**CALIFORNIA COASTAL COMMISSION**

## APPEAL STAFF REPORT: SUBSTANTIAL ISSUE DETERMINATION & DE NOVO HEARING

**Appeal Number:** A-3-SLO-15-0001

**Applicant:** Jack Loperena

Figure 8: Enlarged Portion of State of California Acquisition Map from 1955 showing the Toe of Bluff that existed on the Loperena property in 1955

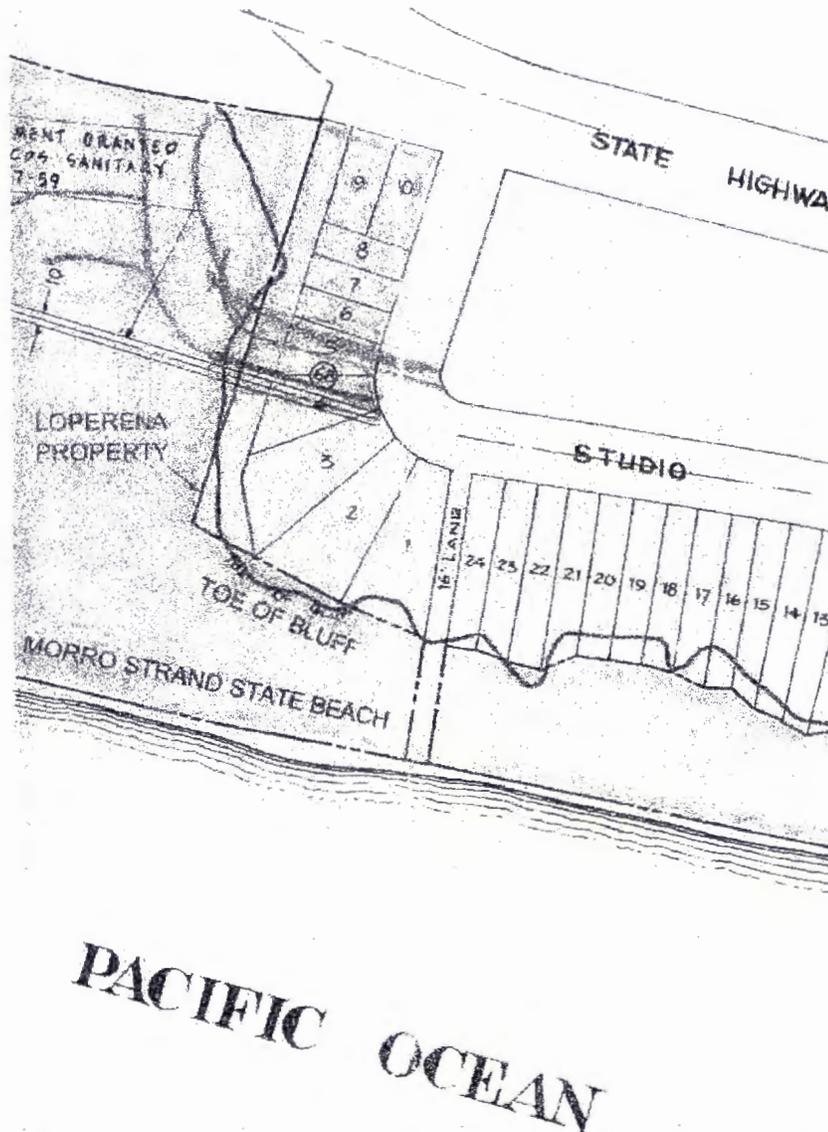
Figure 8 is an enlarged portion of State of California Acquisition Map from 1955 showing the toe of bluff that existed then on the Loperena property. The Loperena property was impacted by both the ocean and creek before Highway 1 was built, and now is primarily impacted by the ocean because the creek's alignment was altered. The map depicts that in 1955 (before Highway 1 was constructed in its present day alignment) it might be considered as a "corner lot", which is within a transition area that is part coastal bluff and part inland bluff. If it was partly a coastal bluff then and is impacted by coastal processes such as marine erosion, ocean wave run-up, and wave impact today, it should be considered a coastal bluff.

**Figure 3-2 Planning Commission Approved Project Basement and Main Floor Plans with Board Approved 25 foot Setback from Edge of Rocks and Ice Plant**

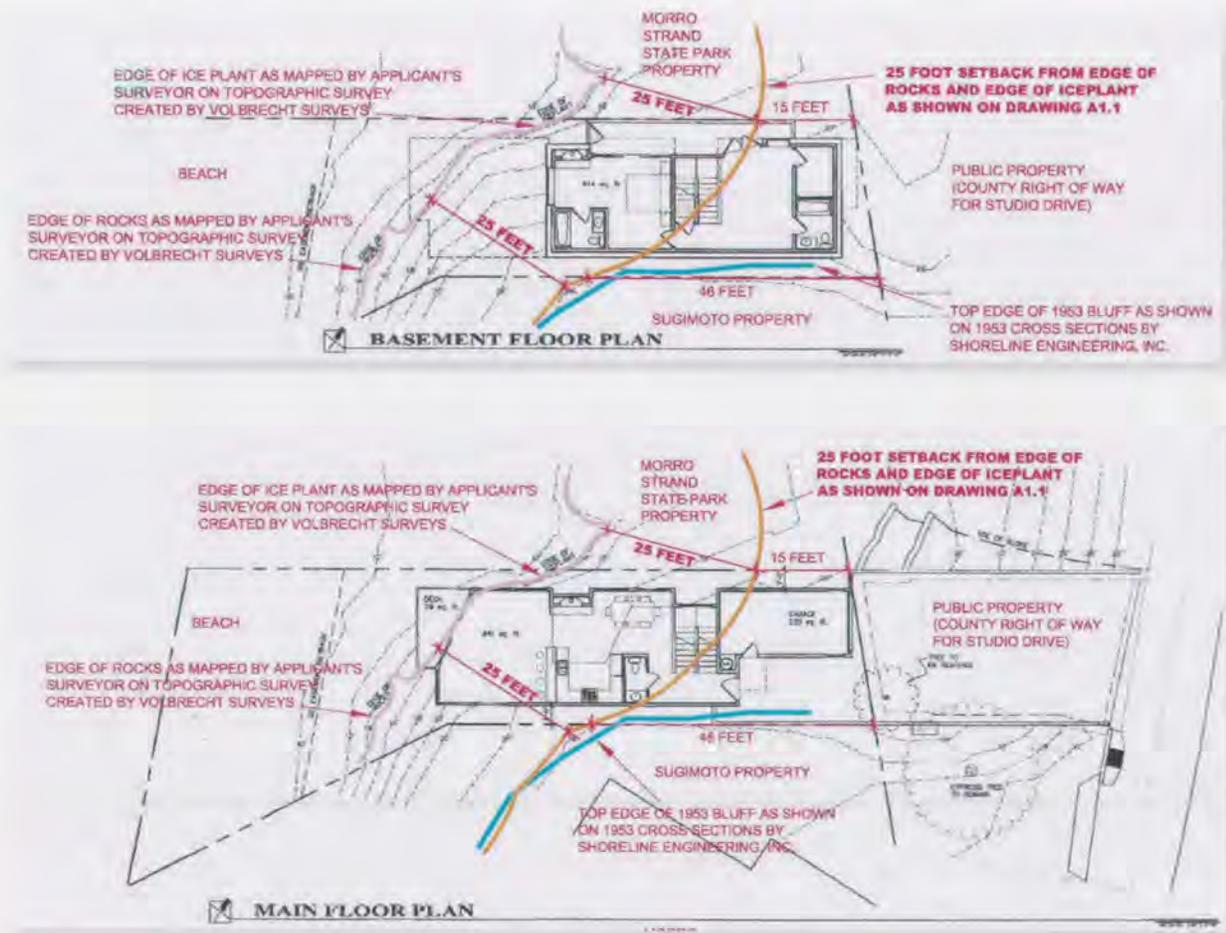
Appellant's December 8, 2014 Letter commented on the Board Hearing staff report. It was recommended that Figures using Applicant's Drawing A1.1, be used to replace Staff Report Attachment 4, since a topographic surveyed drawing is more accurate and easier to verify than Attachment 4 photo-graphic. The HKA December 8<sup>th</sup> Letter provided Figure 1 (shown below as Figure 3-2) based on the setback being applied to the toe of the bluff similar to Attachment 4. The purple line indicates the edge of the rocks and ice plant. The orange line represents the 25 foot setback from the toe of the bluff. The light blue line indicates the top of the bluff as shown in the Shoreline 2014 Study. It was recommend that the Board either use these Figures, or preferably similar figures based on setback from the top of the bluff, so the diagram is consistent with the Board of Supervisors intent. Unfortunately, the BAP did not include a revised drawing.

Figure 4: Cotton Shires Geologic Cross Section 1-1' Showing Proposed Home Extending Over Coastal Bluff and Beach

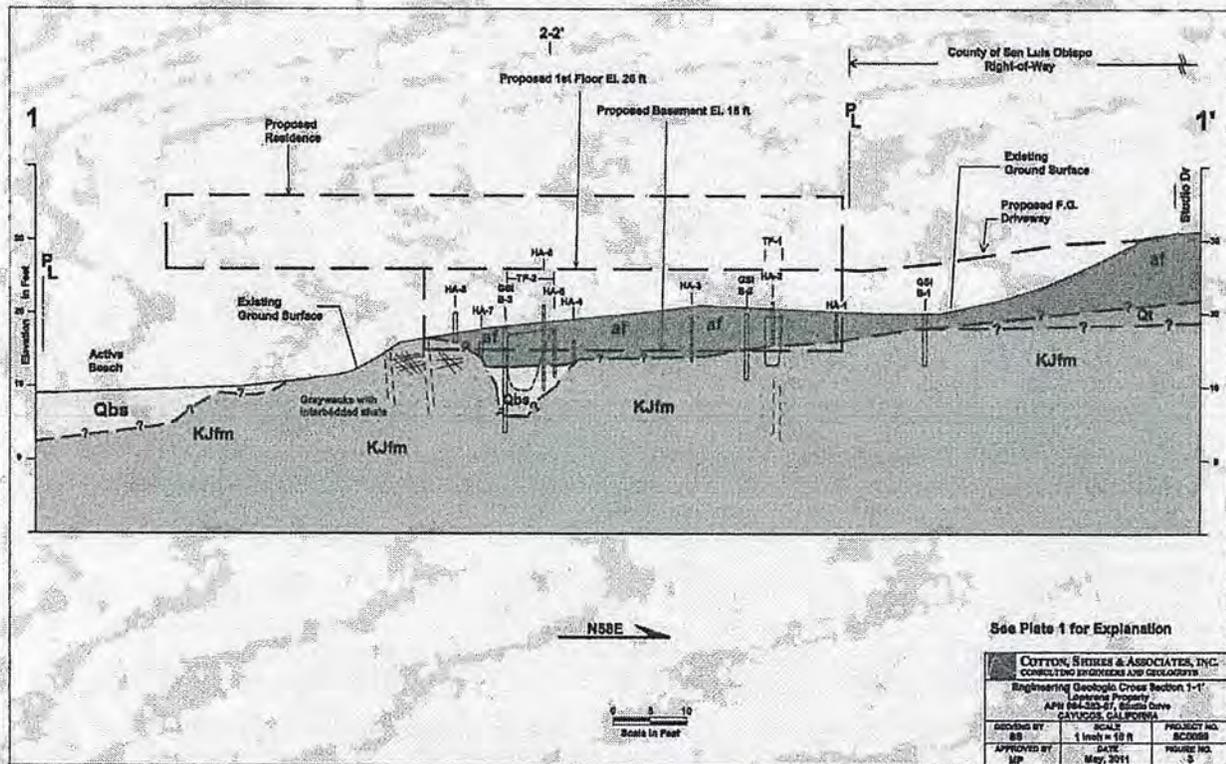
Figure 4 is Cotton Shires Geologic Cross Section which shows the proposed Loperena residence projecting (cantilevered) out over the coastal bluff and what they depict as an "Active Beach". The area between the Active Beach and the landward portion of the residence is the coastal bluff, as defined by the California Coastal Commission.

FIGURE 2: 2014 TOPOGRAPHIC MAP BY SHORELINE ENGINEERING, INC. SHOWING 1953 TOP EDGE OF BLUFF AS DEPICTED ON CROSS SECTIONS BY SHORELINE ENGINEERING, INC.

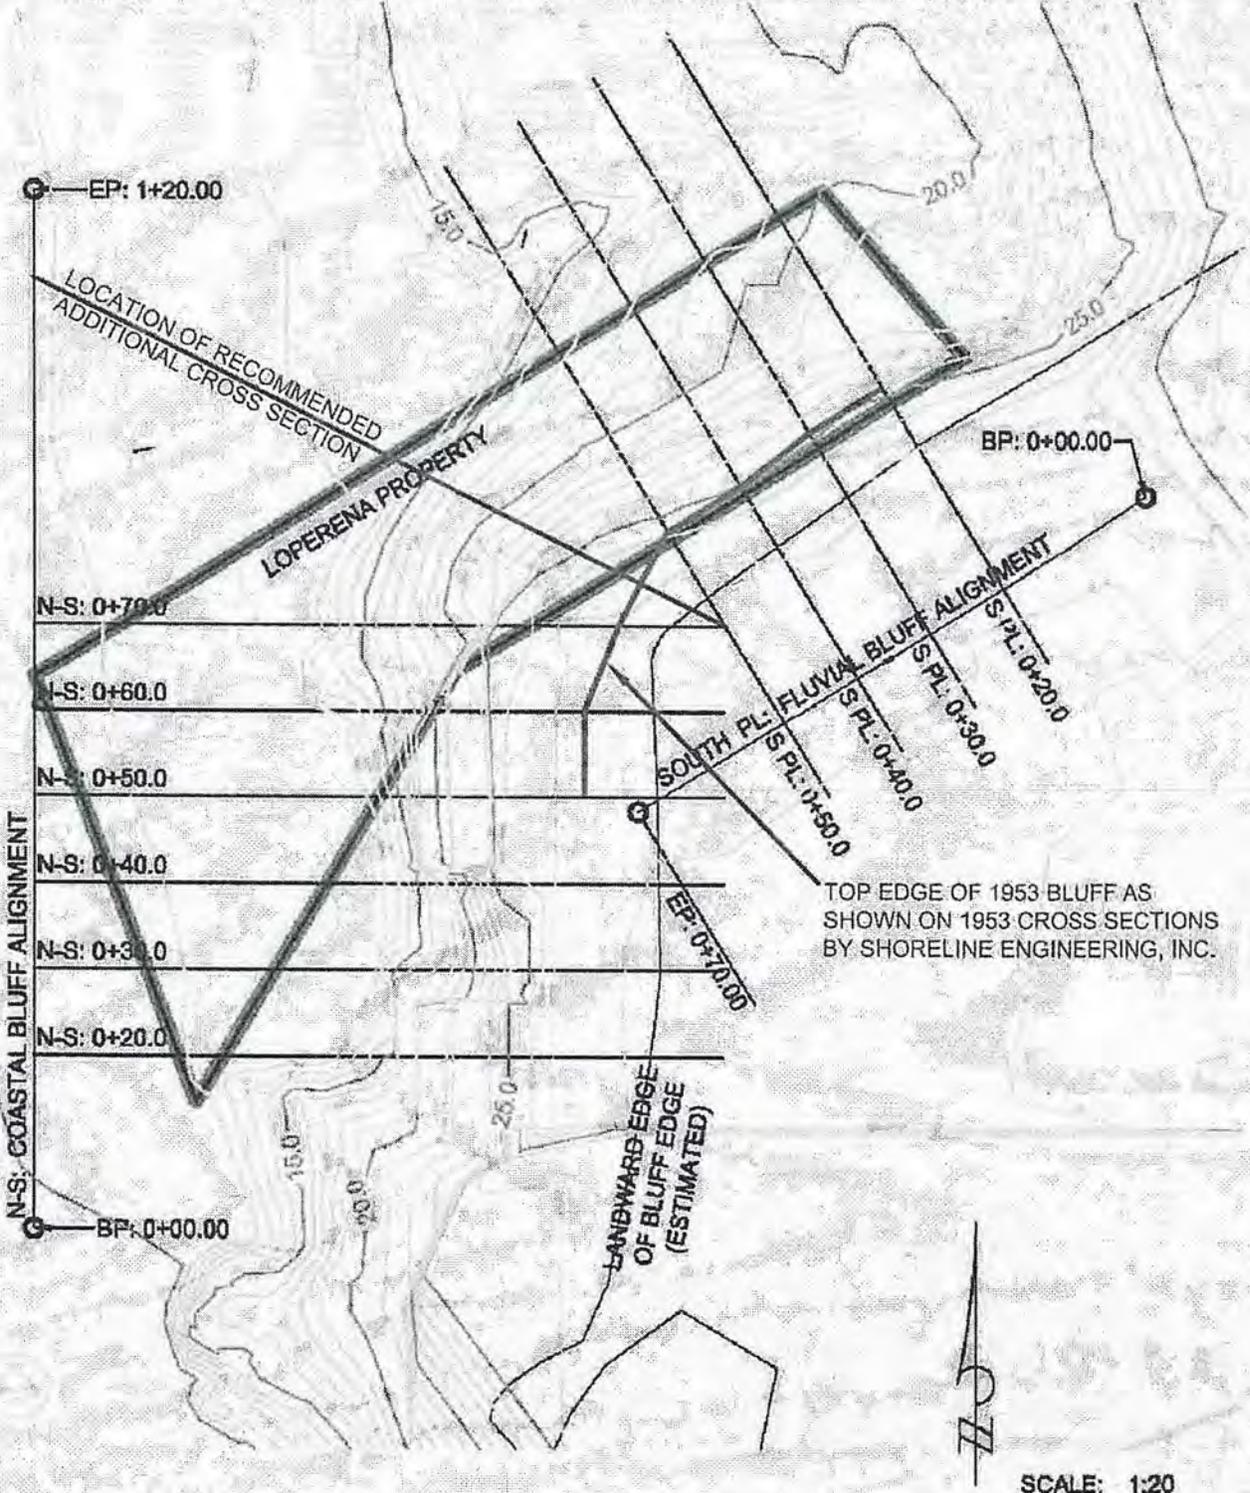
- 9 Based on the 1953 cross sections provided in the Shoreline Engineering study, we have mapped the top edge of the natural 1953 bluff on the 1953 and 2014 topographic maps provided Shoreline Engineering, see attached Figures 2 and 3. Most of the proposed development on the Loperena property is located below the top of the bluff and on the bluff face. SLO Coastal Plan Policies page 10-10, Policy 11 Development on Coastal Bluffs states "New development on bluff faces shall be limited to public access stairways and shoreline protection structures. Our understanding of Policy 11 is that a residential development is not allowed on the bluff face.

FIGURE 5 - 1965 CALTRANS AERIAL PHOTOGRAPH (APPROXIMATE SCALE: 1 INCH = 50 FEET)

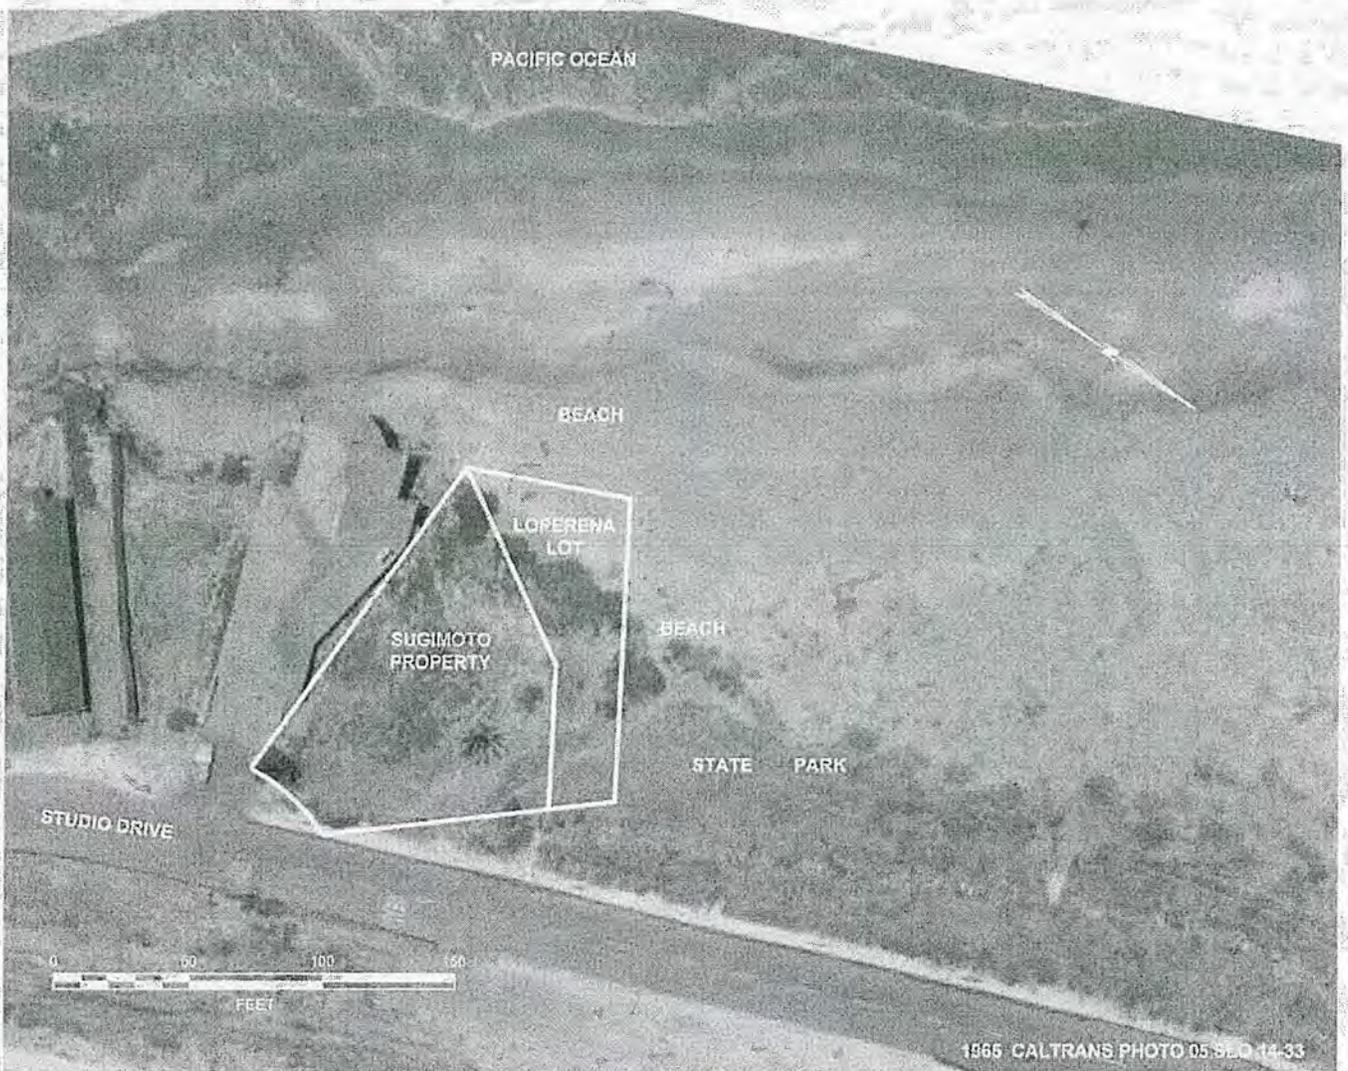
The Caltrans photographs used in the Shoreline Engineering study provide additional evidence that the toe of the bluff has historically been subject to marine erosion; and therefore this bluff is a coastal bluff. Figures 5 and 6 (attached) are the Caltrans photographs, which show evidence of recent erosion on both the Sugimoto and Loperena properties. The evidence of erosion includes areas of barren rock and areas stripped of vegetation. Evidence of ocean wave runup onto the Loperena property is visible in both Figures 5 and 6 and on Figure 8 (taken before the construction of Highway 1) and Figure 9 (taken after the construction of Highway 1 which involved placement of fill on the Loperena property). Our submittal "Review of Draft EIR Comments" dated 1 August 2013 photographically documents wave runup reaching and impacting the bluff face on the Loperena property during the last few years.

Attachment 4 of the County's Final Local CDP Action Notice, with 25-foot coastal bluff setback line from beach edge shown in yellow.

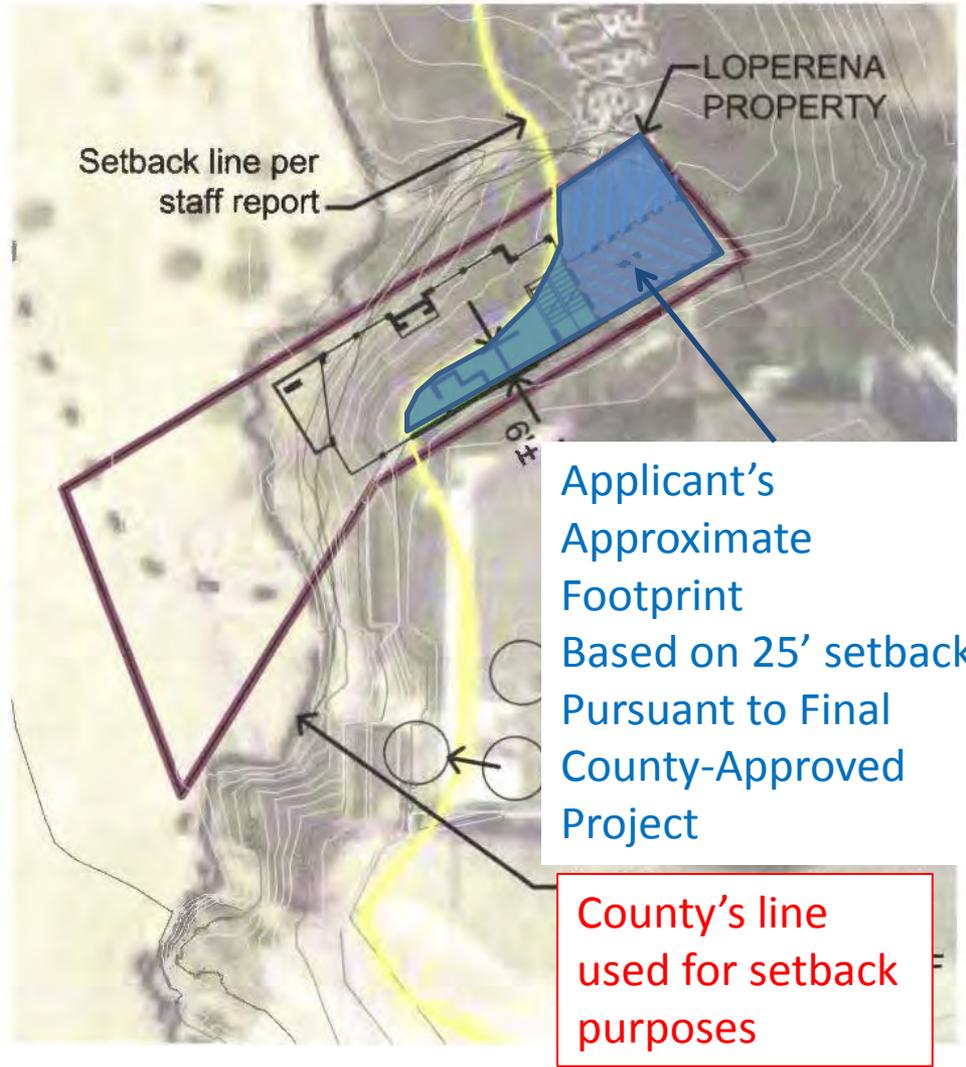
<sup>21</sup> The County's Attachment A (see Exhibit 5) illustrated a line to be used to designate the 25-foot setback distance; however, the graphic is a photo-representation which is not as accurate as a surveyed line, which the Applicant showed on the plans approved by the Planning Commission. Regardless, both lines approximate the edge of beach and using either line would result in an approximately 500-square foot building footprint, including yard setbacks.

Additionally, in the Appellant's Letter (SJMS) dated December 8, 2014, Exhibit 14, it was recommended that Figures using Applicant's Drawing A1.1 be used to replace Staff Report Attachment 4, Bluff Setback Line, because a topographic surveyed drawing is more accurate and easier to verify than Attachment 4 photo-graphic. The HKA Letter attached to Exhibit 14 provides a figure based on the setback being applied to the toe of the bluff similar to County staff's Attachment 4. The figure indicates the edge of the rocks and ice plant, the 25 foot setback line from the toe of the bluff, and the top of the bluff as shown in the Shoreline 2014 Study. It was recommended that the Board either use this figure, or preferably a similar figure based on setback from the top of the bluff, so the diagram is consistent with the Board of Supervisors' intent. Unfortunately, the revised figure was not included as part of the BAP.
